BOAT HARBOUR REMEDIATION PROJECT

EXTERNAL TECHNICAL REVIEW

FINAL

Re: External Technical Review of the Boat Harbour Remediation Project - FINAL

PREPARED BY: RC	FIGURE TITLE CROSS-SECTION OF CONTAINMENT CELL		
CHECKED BY: SB	CLIENT: IMPACT ASSESSMENT AGENCY OF CANADA		
APPROVED BY: EC	SCALE: NTS	PROJECT NO: 2155-001	FIGURE NO: 2-2

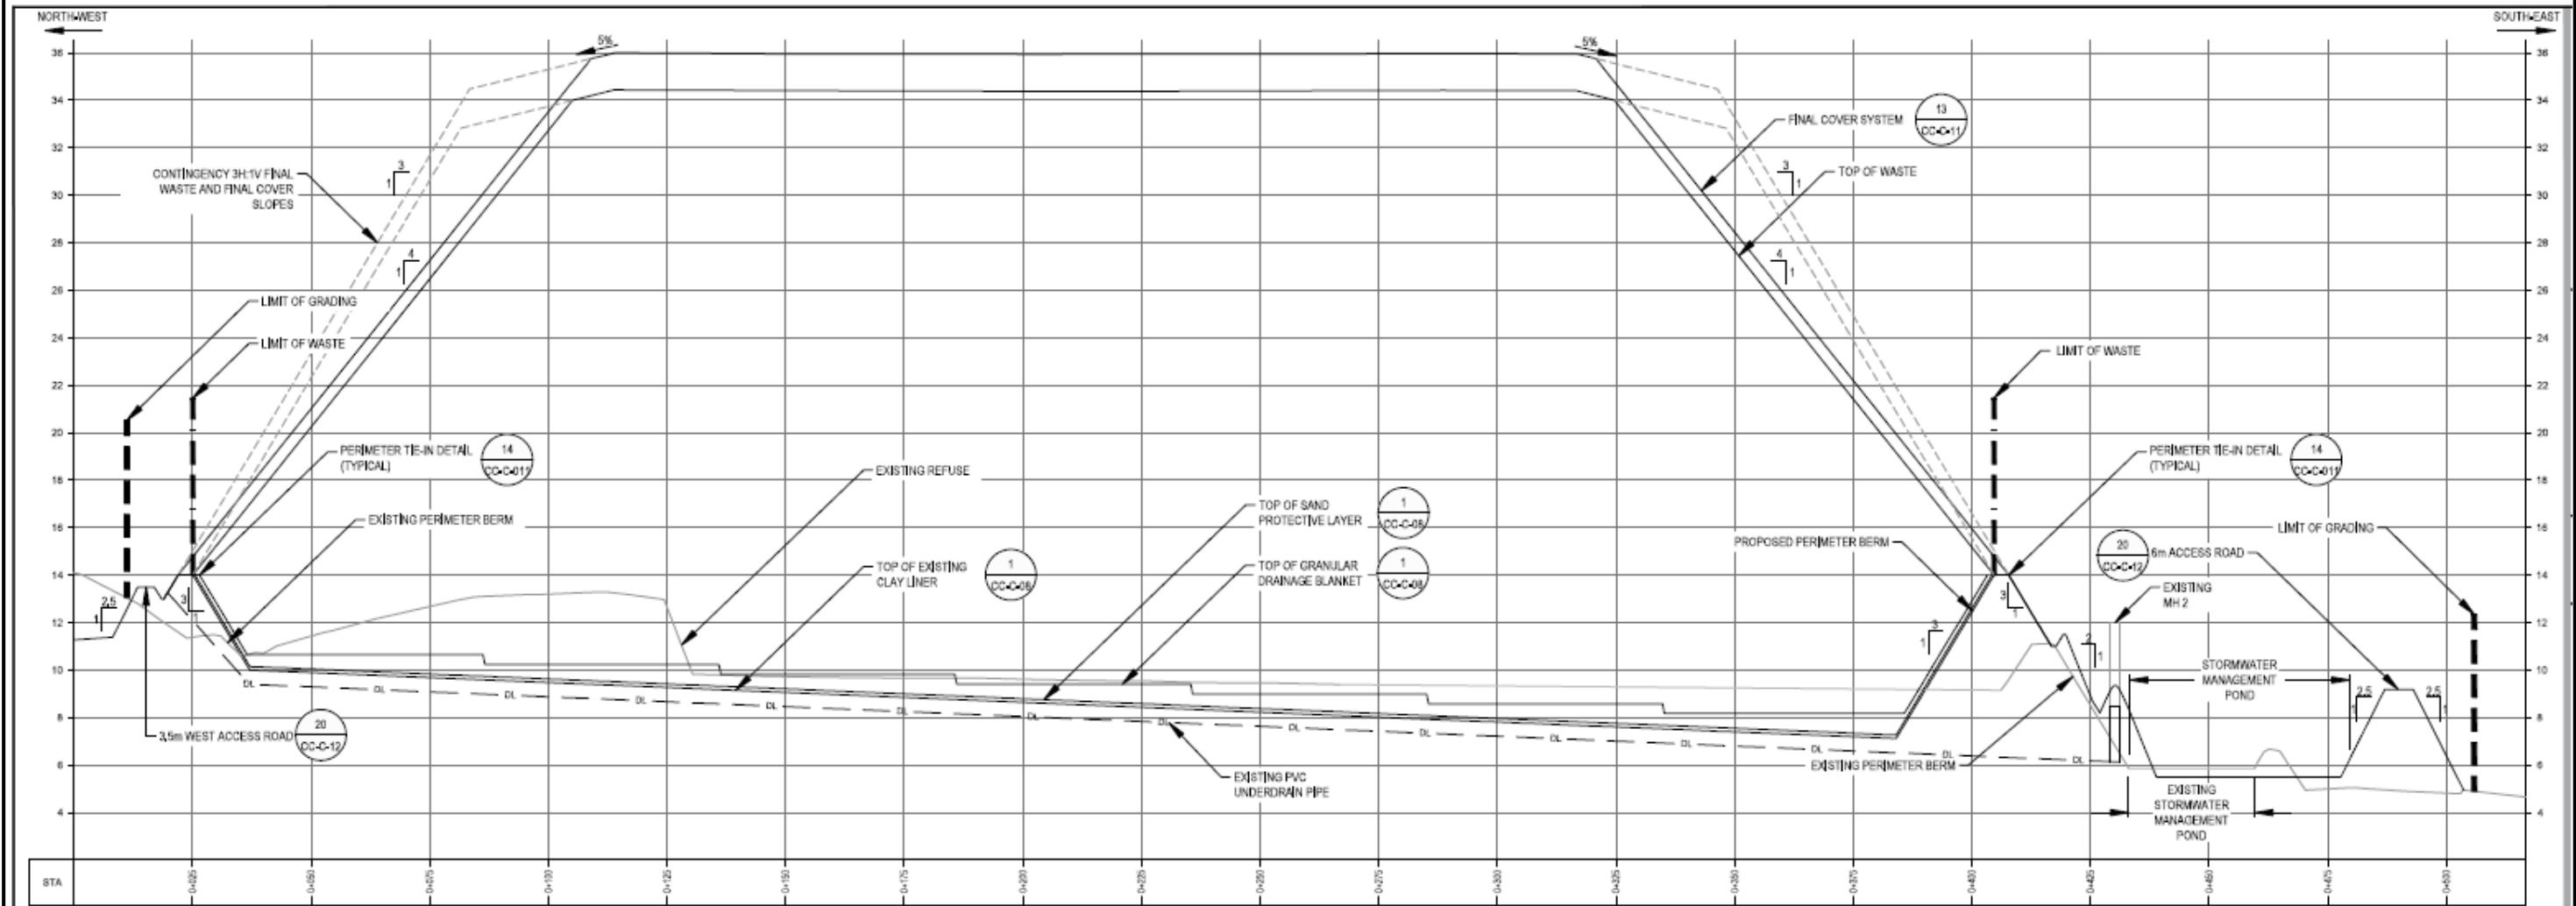
- e. Slope Stability of Cell Final Cover System: Based on Figure 3.1-3 in the EIS Report (and reproduced in Figure 2-2), the stored sludge may extend as high as 25 m above the base liner system. Insufficient information has been provided to demonstrate that the containment cells 4H:1V or 3H:1V side slopes meet a minimum factor of safety criteria in terms of global stability. Furthermore, the performance of the final cover system considering potential consolidation of the stored sludge is not discussed within the provided documents. As well, the long-term integrity of the geomembrane liner has not been demonstrated in the available documents.
